STAFF REPORT - TOWN OF NORTH CASTLE PLANNING DEPARTMENT

APPLICATION NAME & NUMBER
 121 Lafayette Ave [2021-023] – Site Development
 Plan for Rooftop Solar

76 panel 32.68 kW rooftop mounted solar system with roof addition.

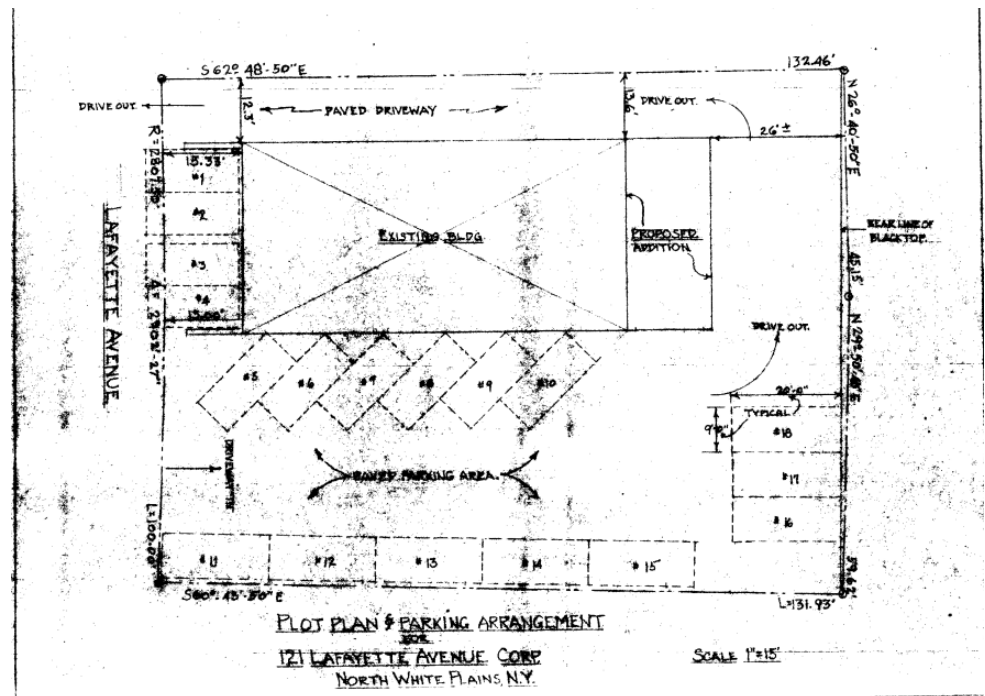
1. The submitted site plan depicts the property being used as an office and warehouse. It is noted that the Planning Department does not have any site plan approval for this site on record. Documentation in the Building Department indicates that the site was formerly an office building.

It appears that the off-street parking required for 121 Lafayette Ave is to be provided on 123 Lafayette Ave per documents in the Building Department files. However, it appears that 123 Lafayette is being used as a landscaping/contractor's yard.

2. Based upon the existing uses in the building, a total of 18 off-street parking spaces are required. It is noted that the 8 parking spaces are in front of the building are not located entirely on the subject property. The Applicant will need to obtain a license agreement from the North Castle Town Board to continue to utilize the parking spaces and a variance to back cars into the road from the Zoning Board of Appeals. In addition, none of the outdoor parking spaces can be counted toward meeting the off-street parking requirement. The site plan states that there is a garage where some of the required off-street parking is provided. The floor plans should be revised to depict the proposed parking layout and number of spaces in the garage. The site plan should be revised to depict the size of the off-street parking spaces in the parking lot and the aisle width between rows of parking. If all of the off-street parking can't be provided on the site, the Applicant will need to seek an off-street parking variance from the Zoning Board of Appeals.

3. The site plan depicts a yard area that appears to conflict with the proposed off-street parking spaces. The Applicant should clearly delineate the proposed yard area on the site plan.

4. The site plan depicts an outdoor yard area, temporary bins for organic recycling and outdoor materials and storage. The Town Code permits the proposed outdoor uses only when determined by the Planning Board as accessory and essential to a permitted use and only when such storage areas do not exceed 15% of the lot area, are suitably screened and are approved by the Planning Board as to location and screening.

5. The Applicant is proposing a roof addition (overhang) for additional solar panels. The Applicant should submit a site plan depicting the location of the roof addition in relation to the property lines. The plan shall also contain a zoning conformance table.

The Building Department will need to confirm that the current uses on the site are permitted and that there are no current issues regarding the existing use of the property.

The Applicant should provide additional clarity to the Planning Board regarding off-street parking provisions for this lot.
